Appln. No.10/656,710
Amendment & Response dated June 16, 2005
Reply to Office Action of: April 11, 2005

Amendments to the Drawings:

The attached replacement sheets of drawings include changes to Figs. 6, 8, 10, 17, and 19. These changes are shown in red on the attached annotated marked-up sheets and described in detail in the Remarks section below.

FIG. 8

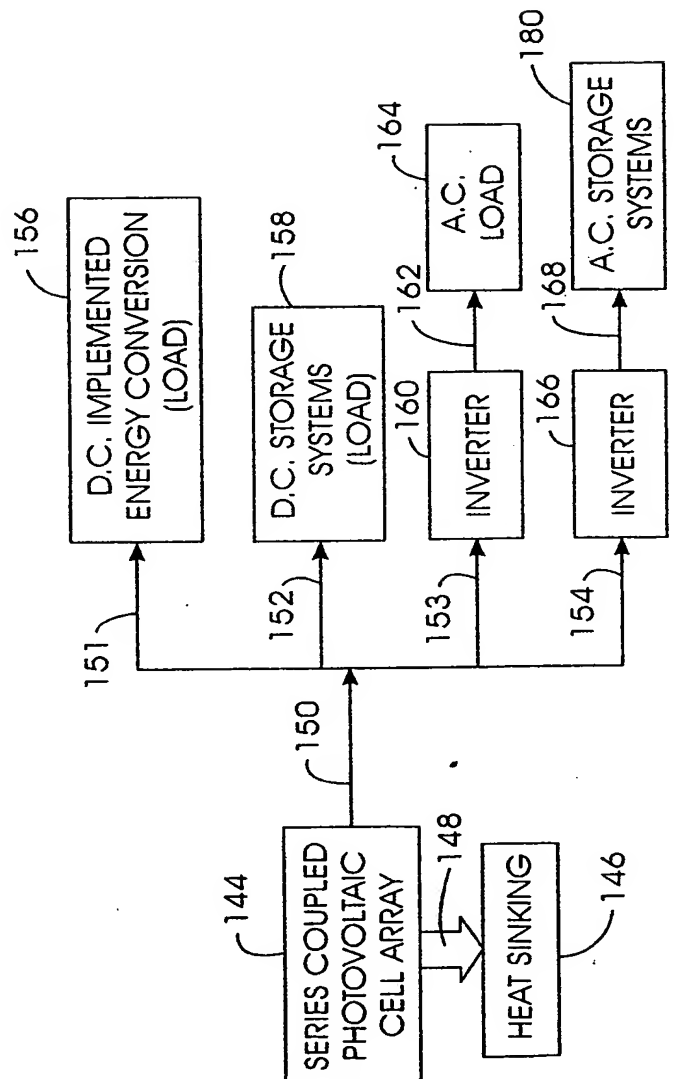
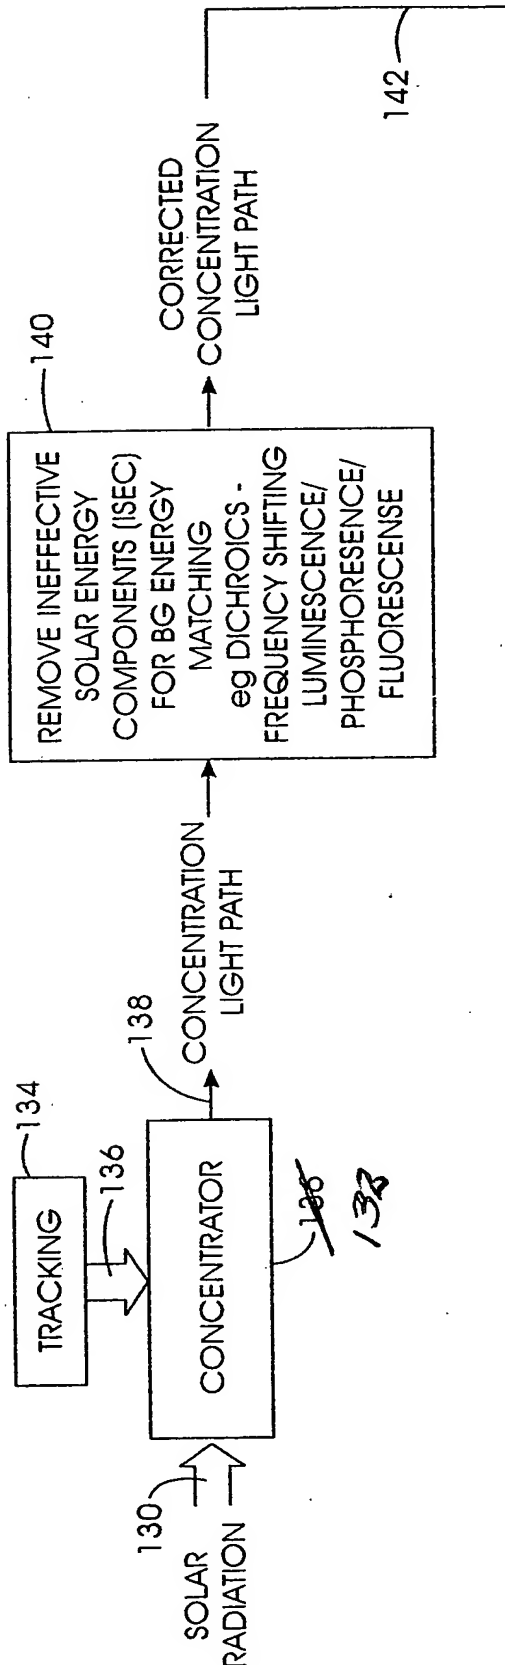
It is noted that the number "136" was used in two locations in Fig. 8. The number 136 representing a concentrator is changed to - - 132 - - in keeping with the specification at page 12, line 28. It is noted that the number 180 has been used to designate both an a.c. storage systems block in Fig. 8 and a mirror in Fig. 10. The number should be - - 170 - - in Fig. 8 as described at page 13, line 22. The Examiner has indicated that the number 240 of Fig. 11 is not mentioned in the description. With the instant amendment that number has been inserted after the word "load" at page 15, line 2. The Examiner has indicated that the number 532 in Fig. 19 is not mentioned in the description. That represents a numbering error inasmuch as Figs. 20 and 20A commence with the number 530. Accordingly, the numbers beginning at 522 and ending at 532 now are replaced with the number string 521-526. Appropriate amendments have been made to lines 30-34 of page 19. The Examiner has indicated that the number 78 is not mentioned at page 11 of the specification. The specification exhibits a typographical error here, line 15 at page 11 has been further amended to recite: "Hatched areas 72, 74 and 76 reveal very little effective...". That line was earlier amended to insert the term "device" after the term "photovoltaic". Spelling of the latter term has been corrected with the instant amendment. As indicated above, reference sign 132 has been added to Fig. 8 as it was mentioned at page 12, line 28. Similarly, number 170 has replaced the number 180 in Fig. 8. Further, the Examiner has indicated that the reference sign 200 identified at page 14 was not present in Fig. 10. That correction is made with the instant response.

FIG. 17

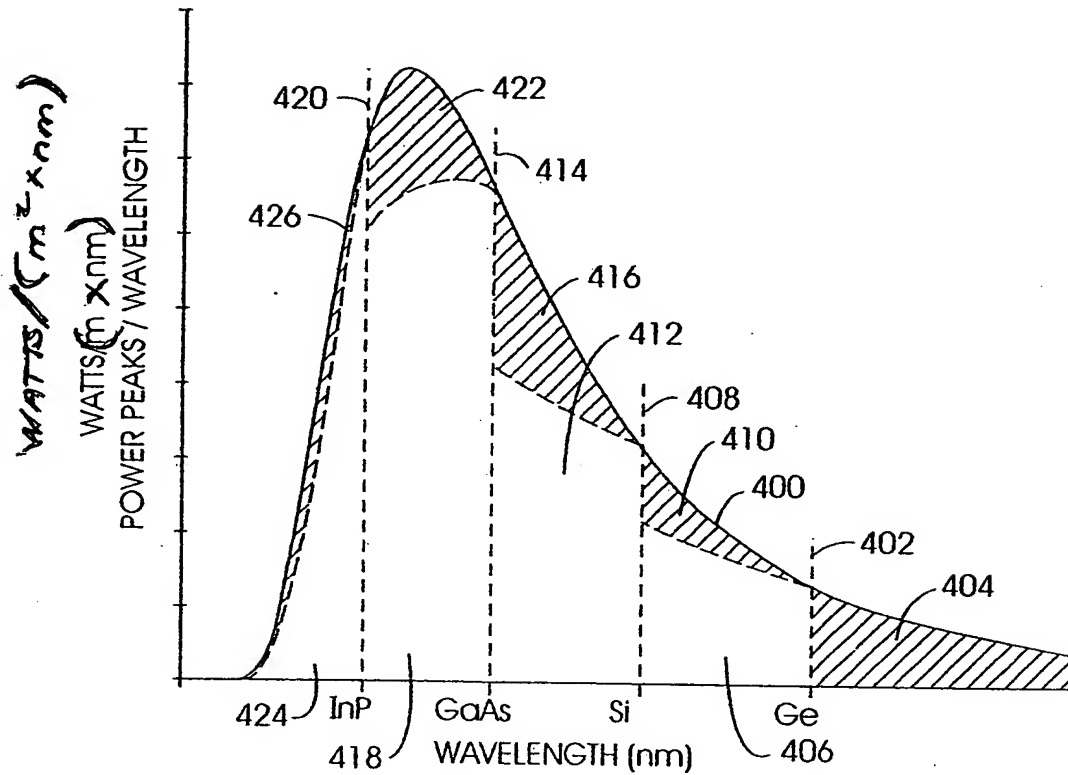
As an additional correction to the drawings, the ordinate labeling at Figs. 6 and 17 is corrected in keeping with the expression at line 30 of page 10.
